Request 11

Answer

Figure 1: Differences in pre/post June 21, 2021 High-Pressure Power Steering Line

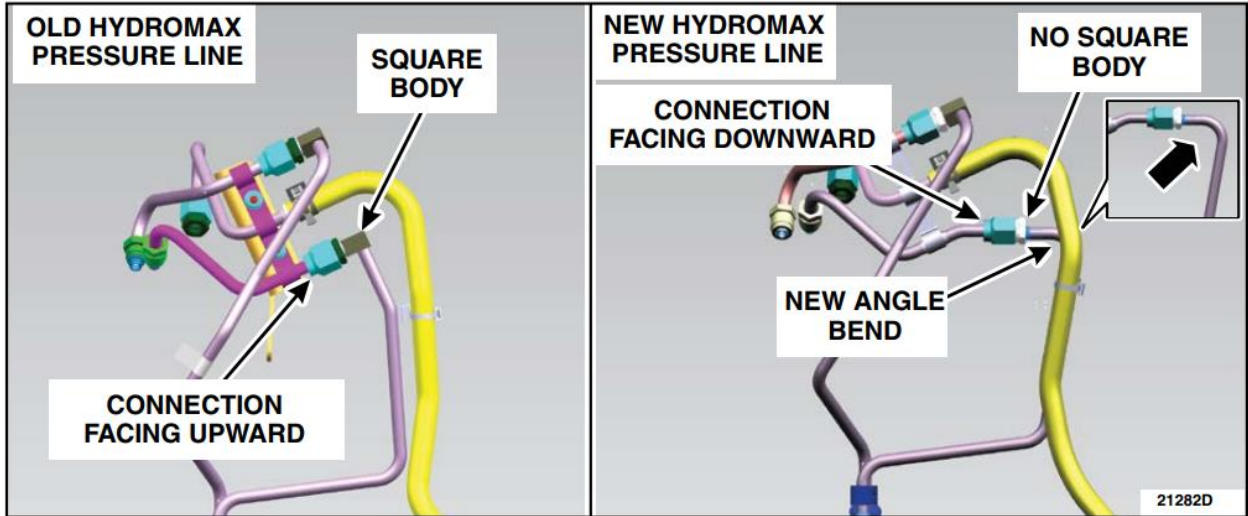
The high-pressure power steering line (also known as "Hydromax Pressure Line") connects to the jumper line of the brake Hydroboost unit with a quick-connect fitting. In response to evidence of line disconnection in the field and ergonomic feedback from assembly plant personnel, Ford Engineering identified that an incomplete connection of the snap-ring in the retention groove can occur due to side loading during installation of the quick-connect fitting in the vehicle assembly plant as a result of ergonomic constraints. On June 21, 2021, the connection interface between the two lines, and the routing of the two lines, was changed to improve the ease of assembly of the parts in the assembly plant and to avoid side loading of the connection between the jumper line and high-pressure power steering line.
